UNITED STATES PATENT AND TRADEMARK OFFICE

Office Action Summary

10/612,918

WILLIAMS, KELLY F.

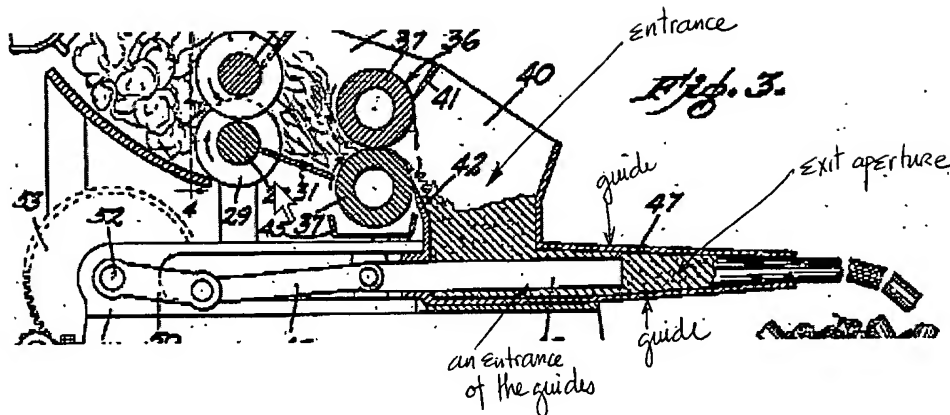
Regarding claim 1, Paxton discloses a compactor comprising: an elongate compression chamber having an entrance and an exit aperture (see the illustration below); a pair of opposing input rollers (37) located at the entrance to the pre-compression chamber, at least one of the rollers provided with rotational drive (page 2, lines 12-14); a moveable plunger (48) operable to sweep a volume of the pre-compression chamber between the entrance and the exit. Note that the limitation “slipsheet” is not positively claimed and it is being claimed as an intended use in the preamble. Paxton discloses the compactor as claimed as set forth above; therefore, the compactor is capable of compacting slipsheet.

Regarding claim 2, the pre-compression chamber has a transverse cross section that is inwardly tapered towards the exit aperture (see the illustration above).

Regarding claim 3, the pre-compression chamber comprises a pair of spaced apart guides defining a passageway having an entrance at one end thereof and defining the exit aperture at the other end thereof, the passageway inwardly tapered at least in a portion in proximity to the exit aperture (see illustration above).
